PRELIMINARY DRAINAGE REPORT FOR THE VILLAS AT CLAREMONT RANCH

See comment letter for
additional comments.

PUDSP-21-001

THE VILLAS AT
CLAREMONT RANCH
PROPOSED DRAINAGE
MAP

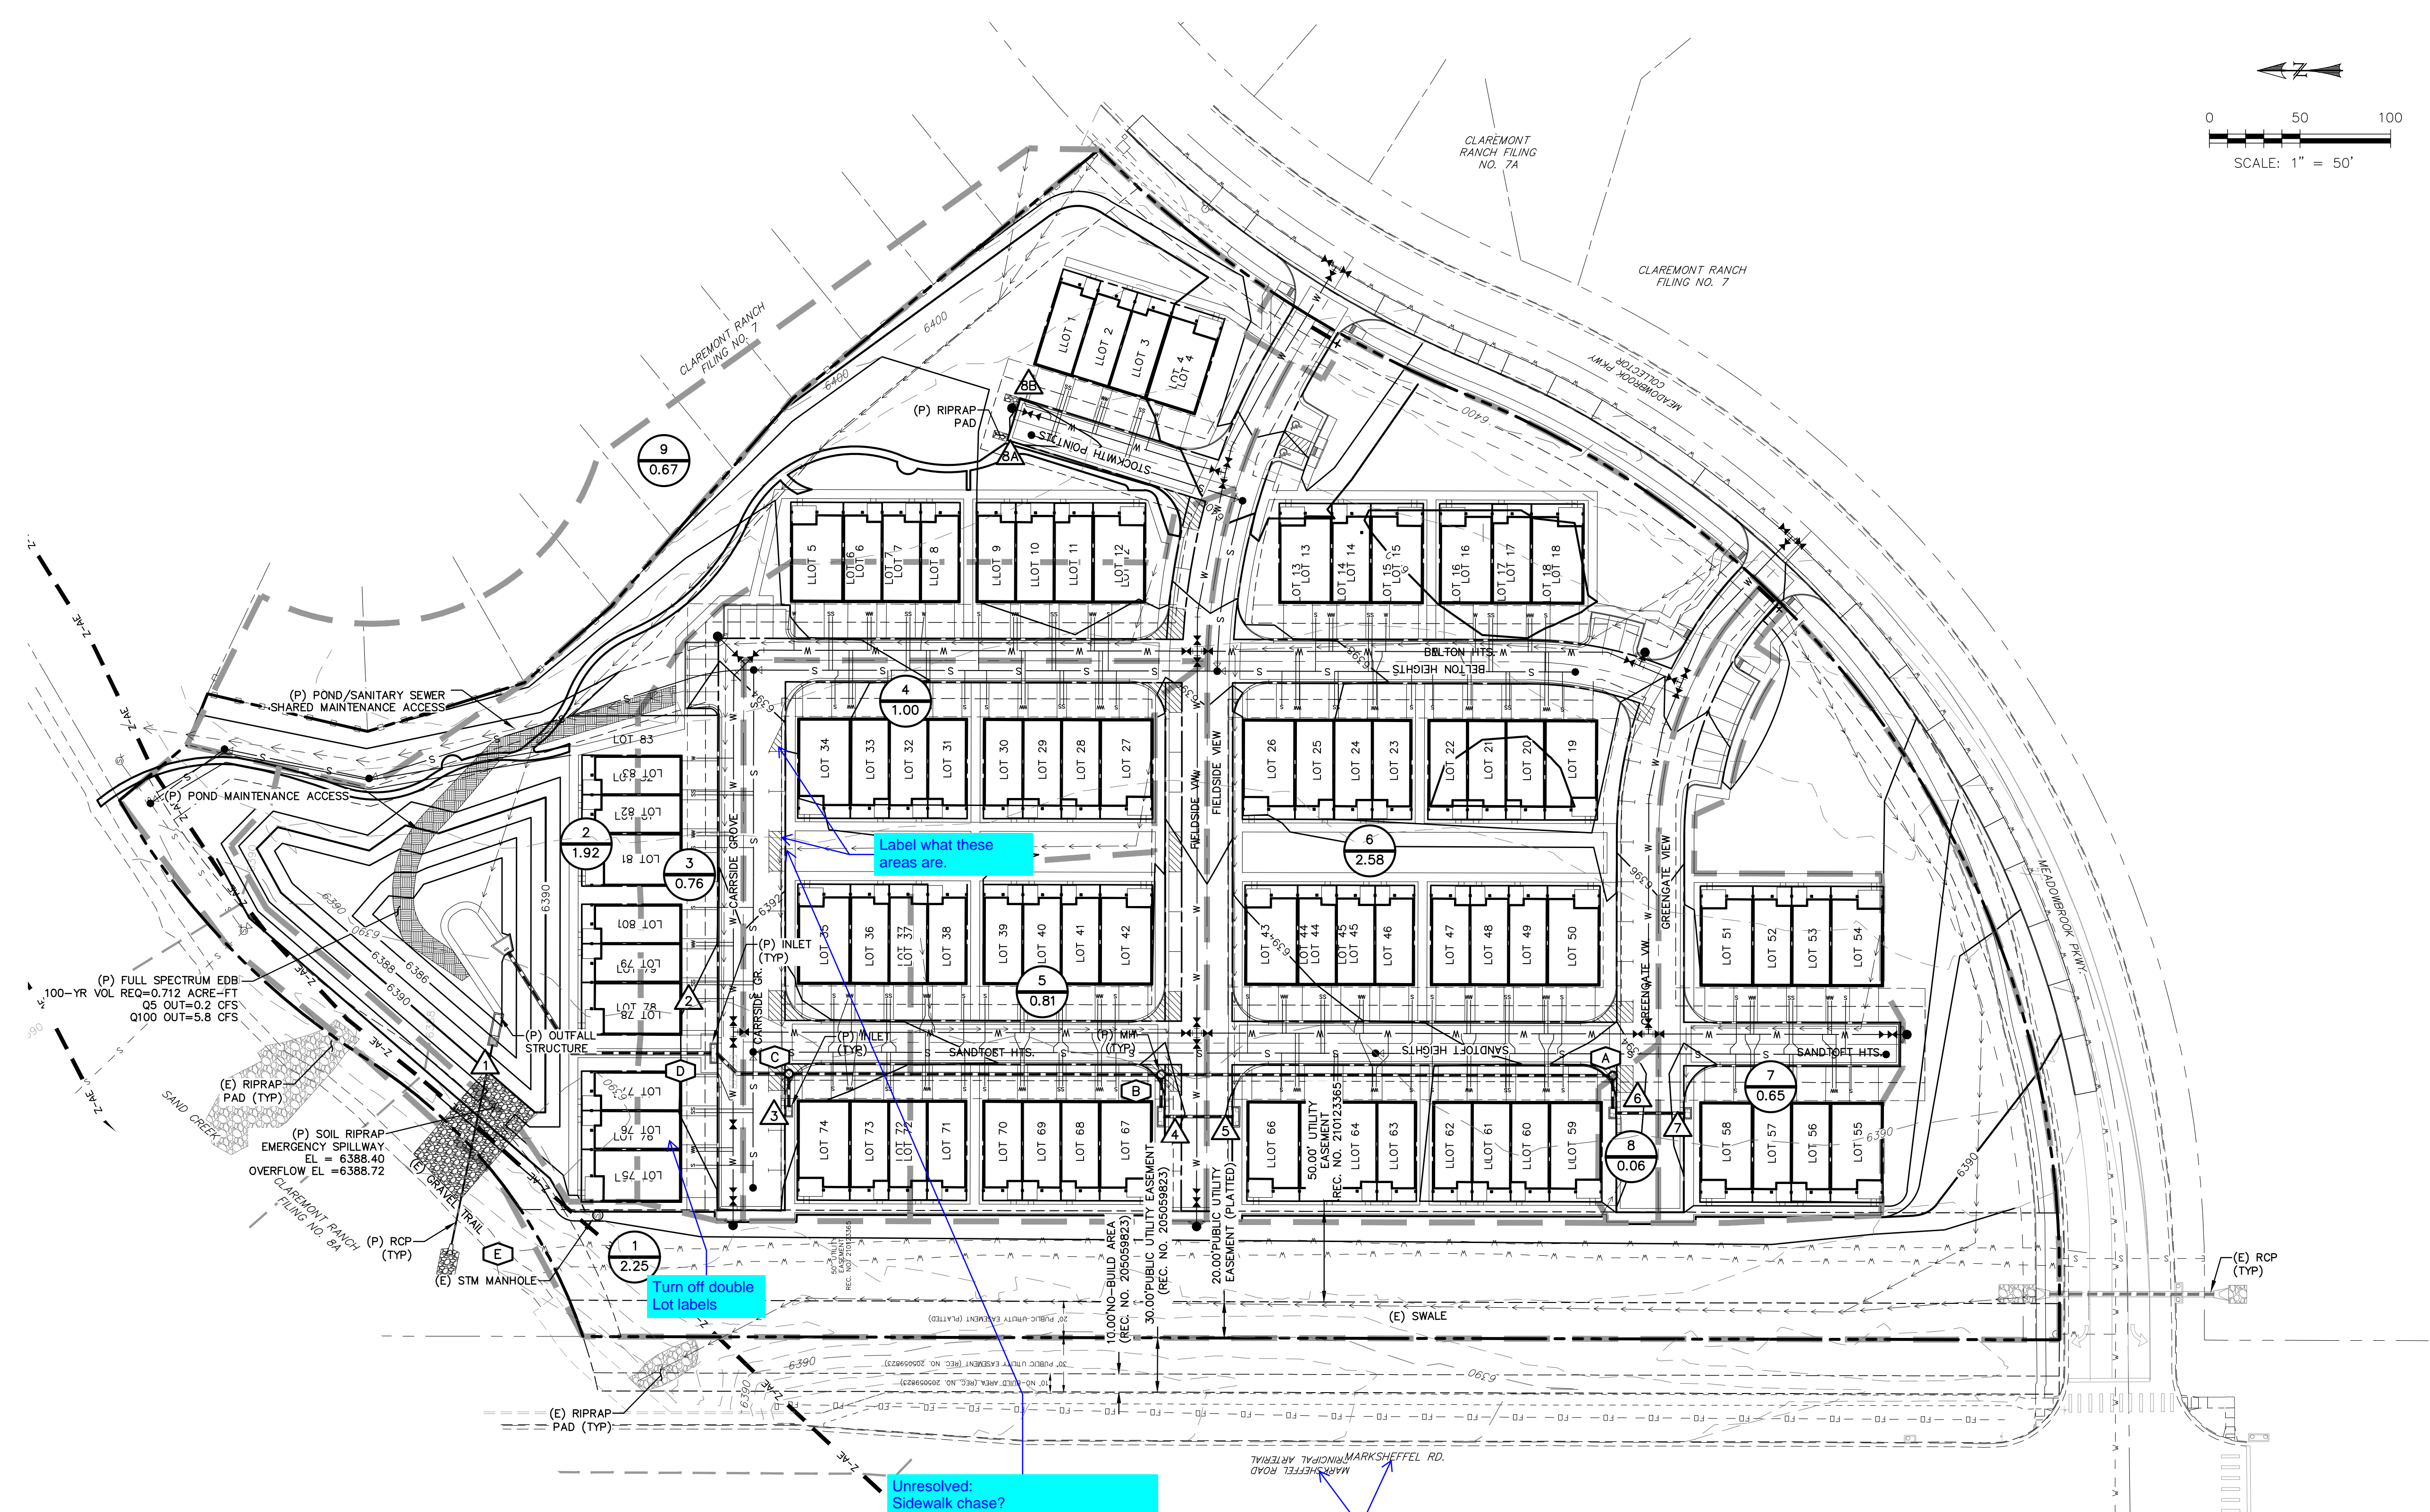
Remove double text
